**AMENDMENTS TO THE DRAWINGS**

**REMARKS**

Fig. 2

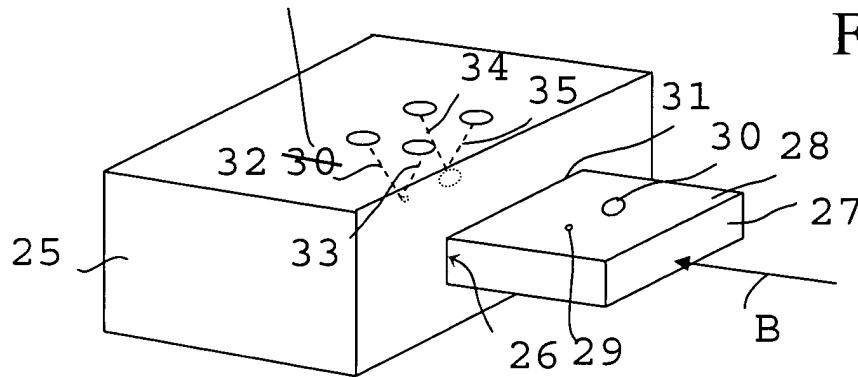
In Fig. 2, the dotted line incorrectly labeled as 30 is replaced by 32.

*30 is replaced by 32*

Fig. 3

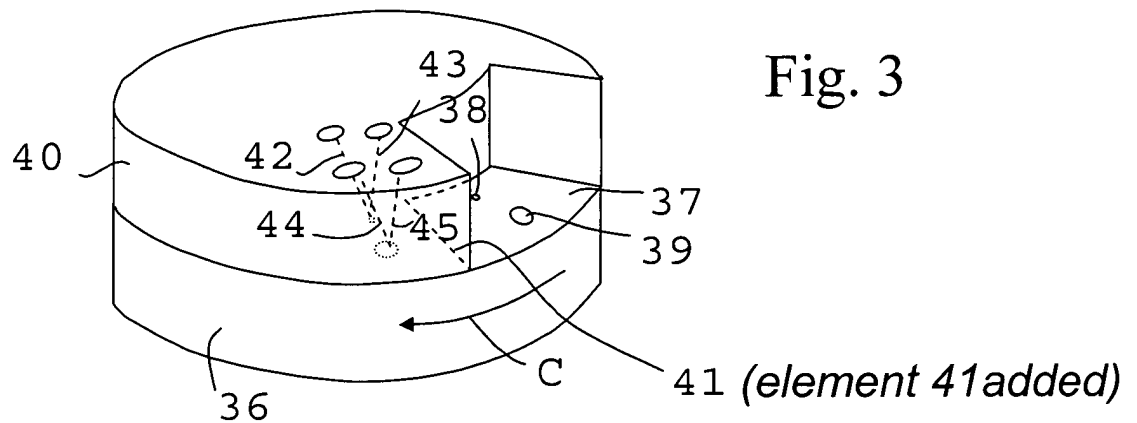
In Fig. 3, the missing element 41 (broken line indicating an edge) has been added to be consistent with the description in the Specification.

Fig. 5c

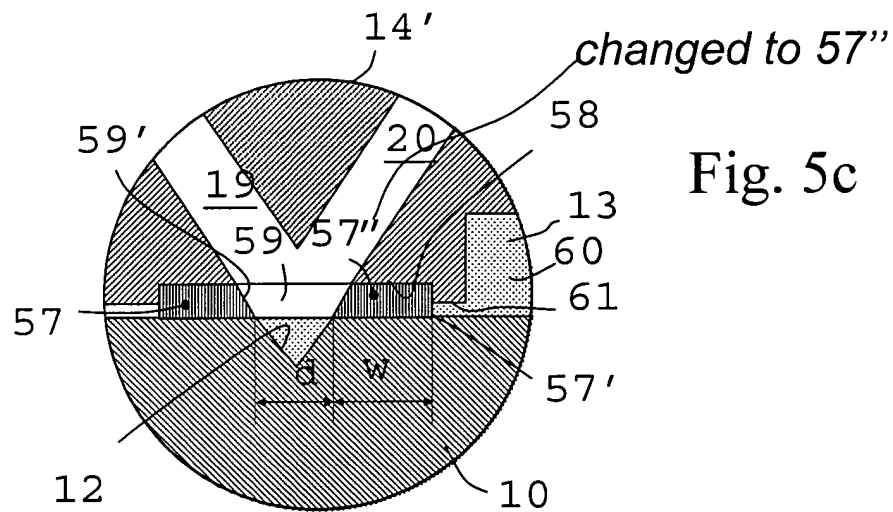
Fig. 5c, the portion of the sealing element having a width w incorrectly labeled as 57' has been replaced by 57", to be consistent with the description in the Specification.
